SUNDRY NOTICES AND REPORTS ON WELLS
*Do not use this form for proposals to drill or to re-enter an abandoned well. Use form 3160-3 (APD) for such proposals.***SUBMIT IN TRIPLICATE - Other instructions on page 2**

Current Wellbore
Sundance Federal 003
30-015-27389-0000
Eddy

Proposed Wellbore
Sundance Federal 003
30-015-27389-0000
Eddy

Permanent Abandonment of Federal Wells
Conditions of Approval (LPC Habitat)

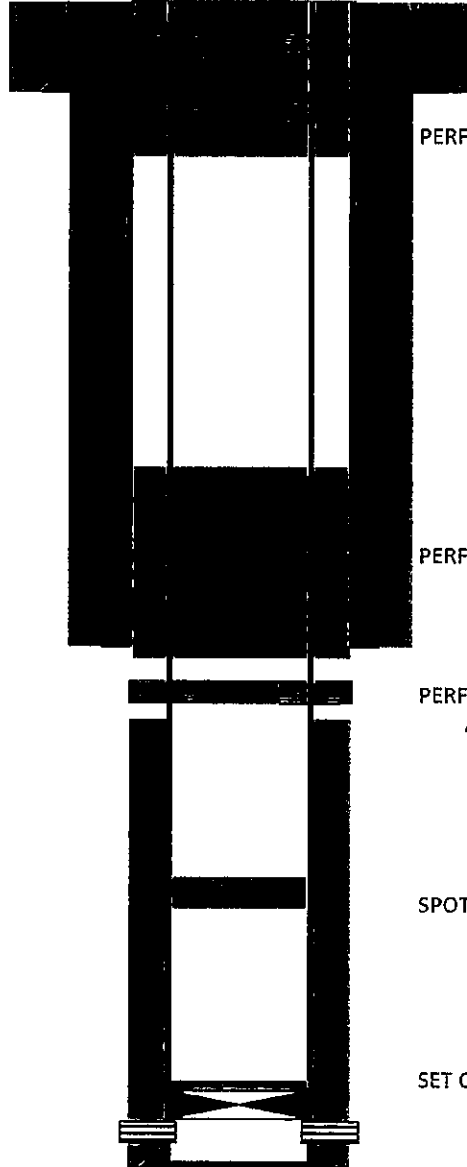
**** BLM REVISED ** BLM REVISED ** BLM REVISED ** BLM REVISED ** BLM REVISED ****

PERF & SQZ 270 SX CLASS C CMT ⁶⁸⁰~~868~~-SURF.

*Solid Plug in/out 5 1/2
From 4110 - 720. woc T.
Can stage through 8 1/2'
section.*

Not Required.
